Airworthiness Directive Schedule

Continental IO-470 Series and O-470 Series

24 February 2022

DCA/CON/174 Oil Filter Adapter Assemblies - Inspection

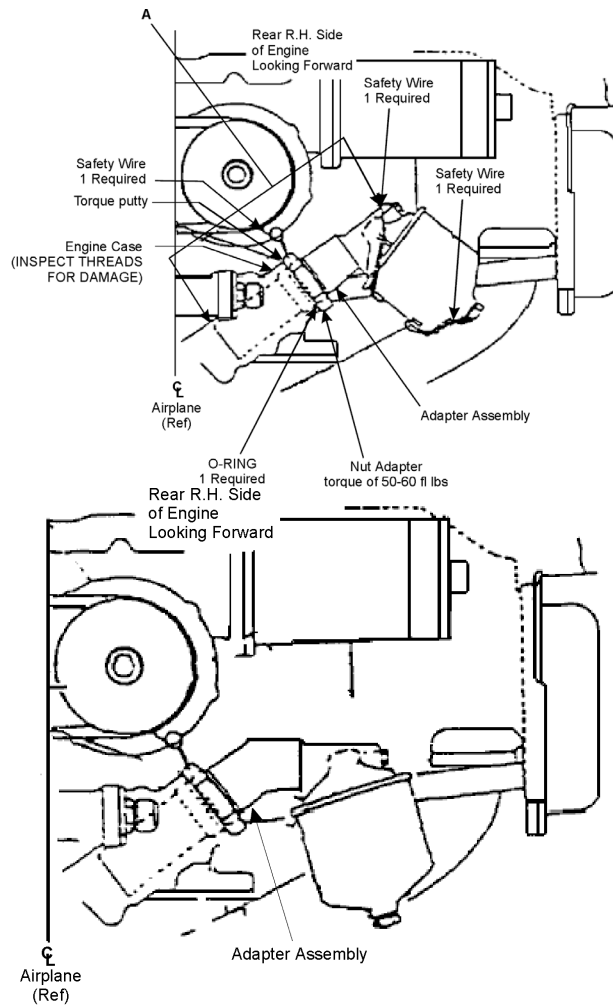
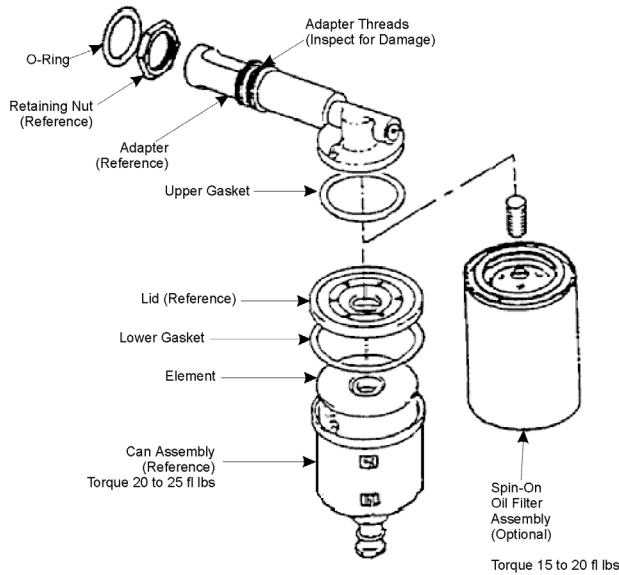
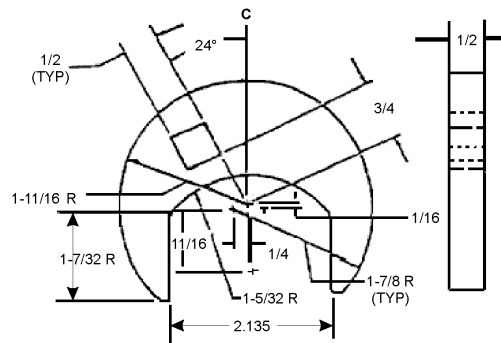
1. For oil filter adapter assemblies that do not have torque putty between the engine filter adapter assembly, nut, and oil pump housing, accomplish the following:

(a) Inspect the adapter locking nut installation for evidence of oil leakage.

(b) Check the torque of the adapter nut installation and ensure that the torque value is within the limits of 50 through 60 foot pounds.

(c) If evidence of oil leakage is found or the torque is not within the 50 through 60 foot pound limit, prior to further flight, remove the adapter and filter assembly, and:

(i) Inspect the threads of the adapter assembly and engine for signs of damaged or cracked threads; and

(ii) Replace any adapter assembly and engine oil pump housing (if necessary) that have evidence of thread damage or cracks.

(d) Apply torque putty between the engine filter adapter assembly, nut, and oil pump housing as specified in the diagram.

2. For oil filter adapter assemblies that do have torque putty between the engine filter adapter assembly, nut, and oil pump housing, inspect the torque putty for misalignment, evidence of oil leakage, or cracks.
